KINGSTON PLACE - NO. 1

AMENDMENT 1 REVISIONS TO DETENTION POND AND FIRE LANE, LANDSCAPE PLAN AND BUILDING ELEVATIONS.

KINGSTON PLACE
SHEET INDEX
SITE PLAN

KINGSTON PLACE MOTOR COURT SITE PLAN
 11.29.2004

Sheet **SP1**
 3 of 12 Sheets
 Designer: HQD
 Drawing Name: 10SP1.dwg
 Path:

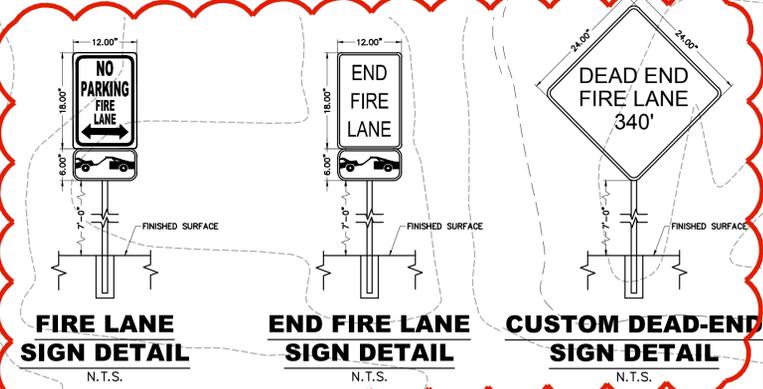
These walls are shown into the Drainage easement (Recpt. No. E3029347). Show the existing Drainage easement on this Site Plan Amendment

Drainage easement has been updated on site plan amendment

SHEET NUMBER: L-1

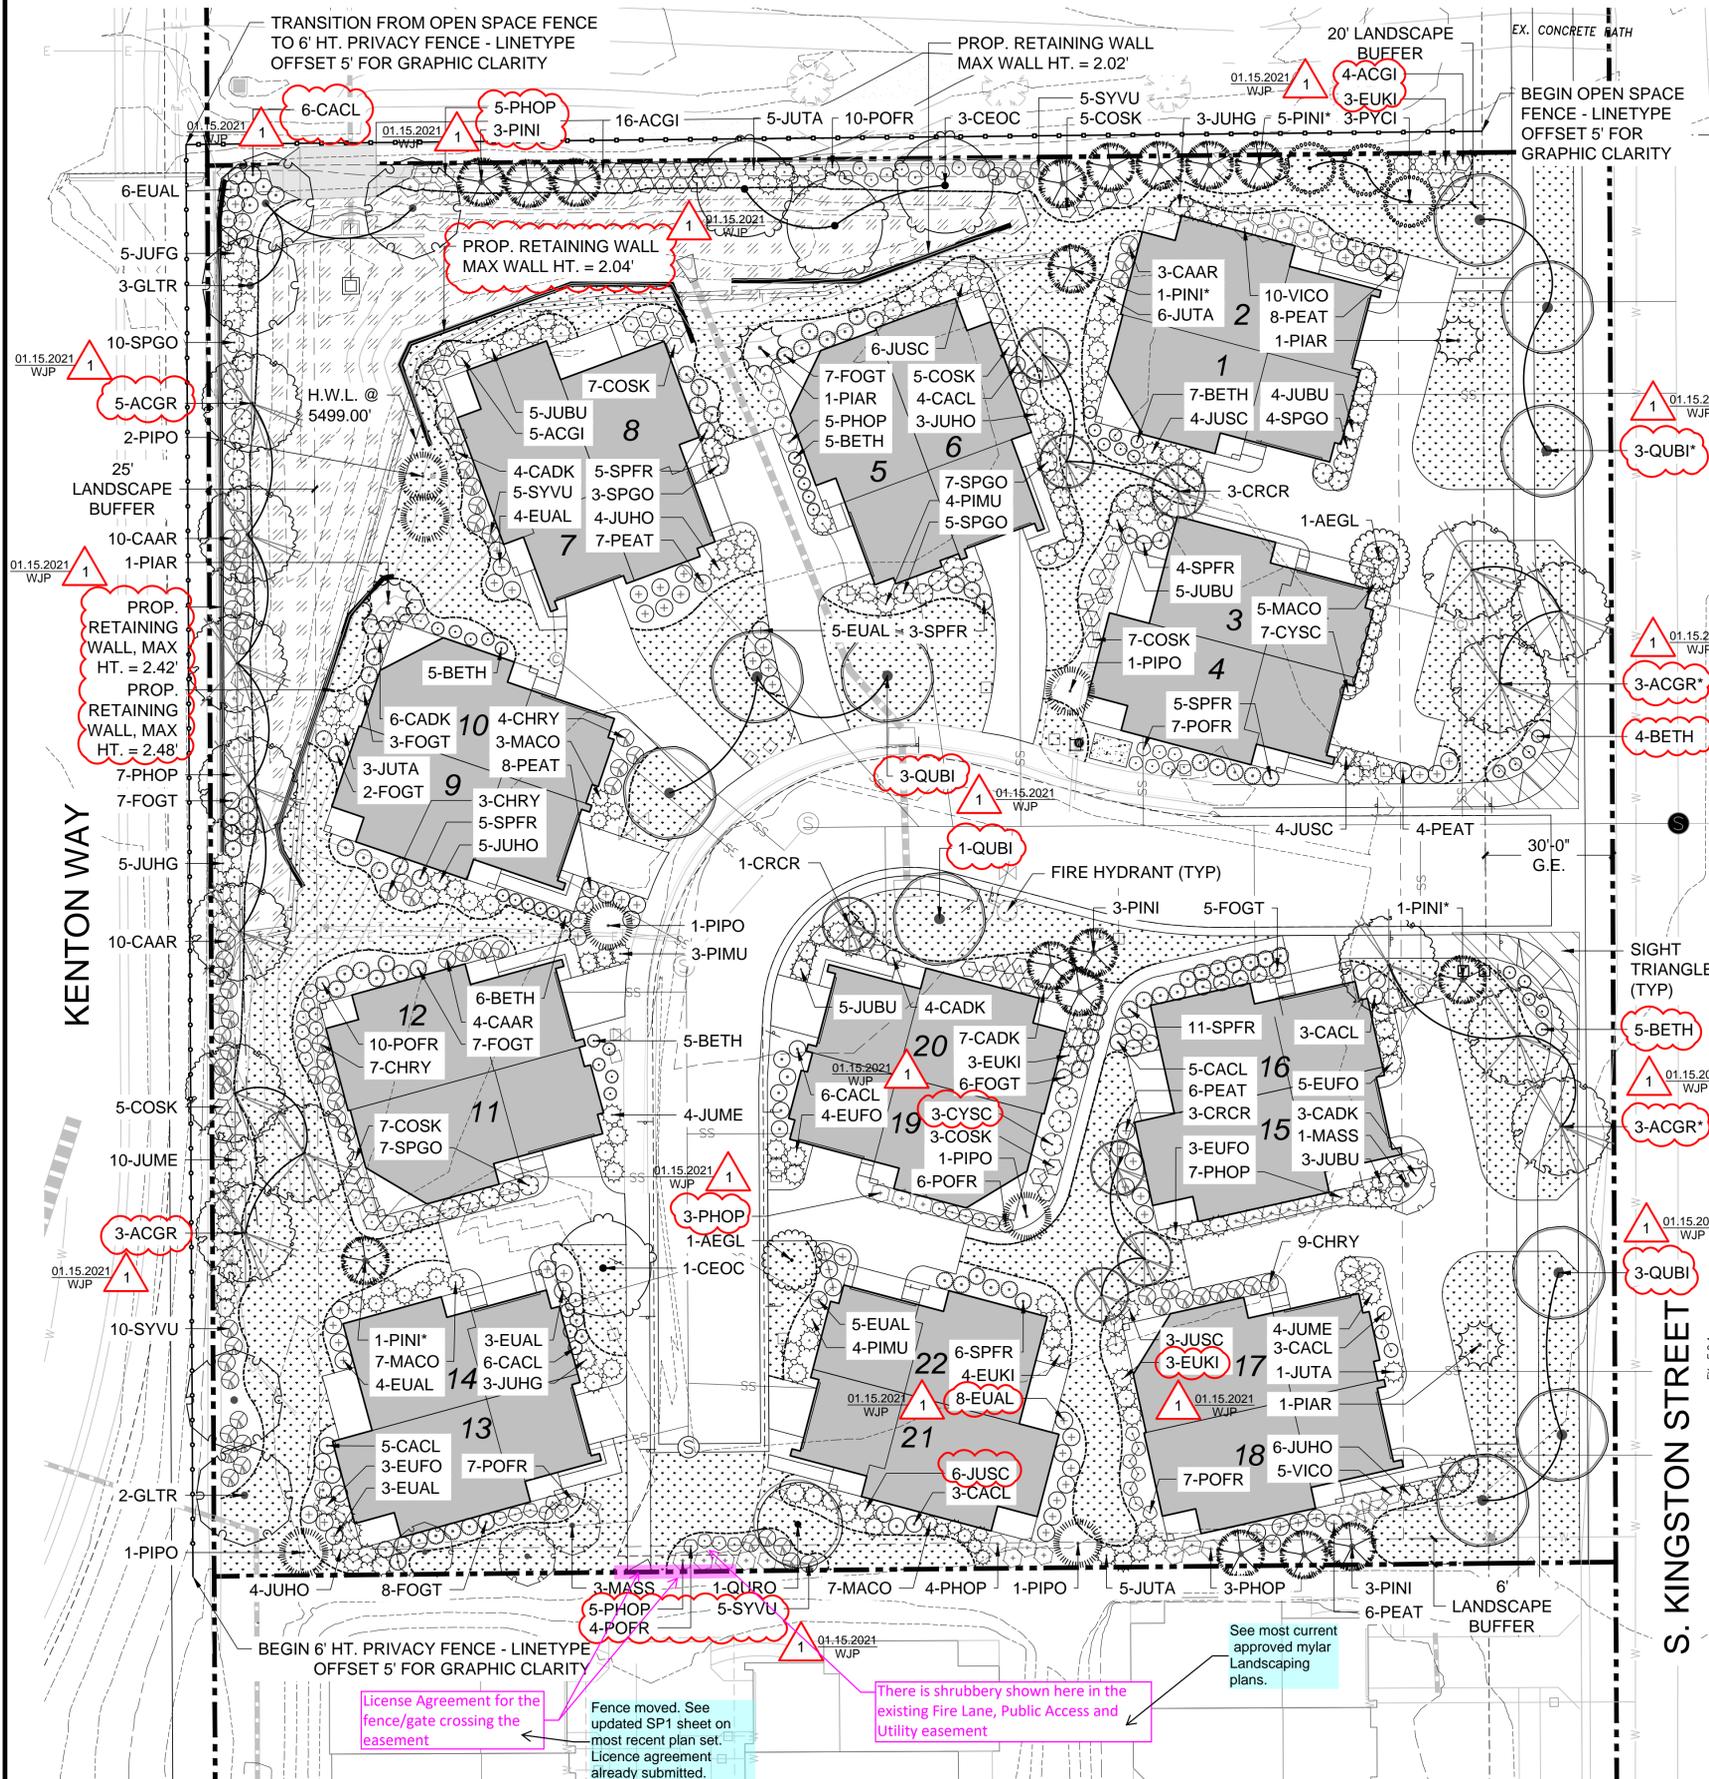
License Agreement for the fence/gate crossing the easement

There is shrubbery shown here in the existing Fire Lane, Public Access and Utility easement

Fence moved. See updated SP1 sheet on most recent plan set. Licence agreement already submitted.

See most current approved mylar Landscaping plans.
